Manual 14H Revisions – Replacement Generation Interconnection Service

Planning Committee
May 8, 2026

New expedited interconnection process for transferring CIRs from a deactivating Generating Facility to a Replacement Generation Resource at the same POI.

Exhibit 39: Replacement Generation Interconnection Service Process

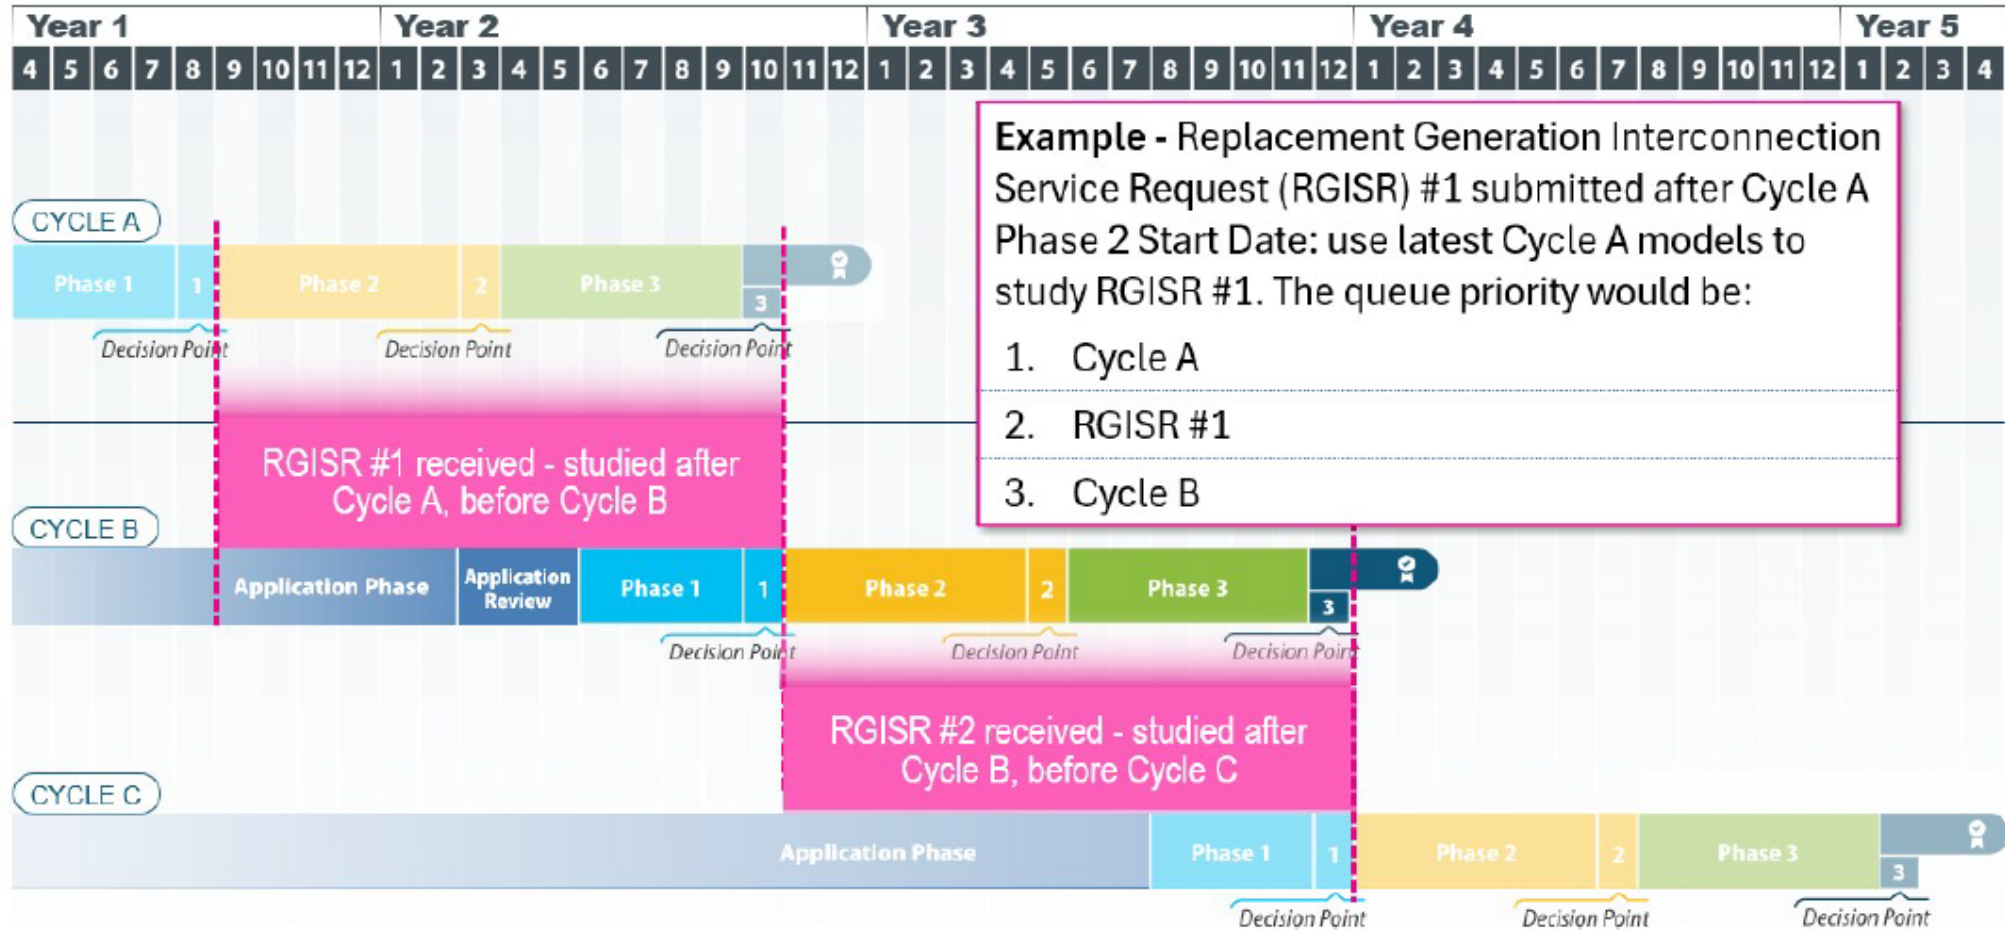
- **New Section 15: Replacement Generation Interconnection Service**
 - 15.1: Overview
 - 15.2: Replacement Generation Interconnection Service Process
 - 15.3: Applications for Replacement Generation Interconnection Service
 - 15.4: Deficiency Review
 - 15.5: Valid Replacement Generation Interconnection Service Request
 - 15.6: Scoping Meeting
 - 15.7: Replacement Generation Interconnection Study
 - 15.8: Generation Interconnection Agreement Negotiation
 - 15.9: Miscellaneous Replacement Generation Request Requirements
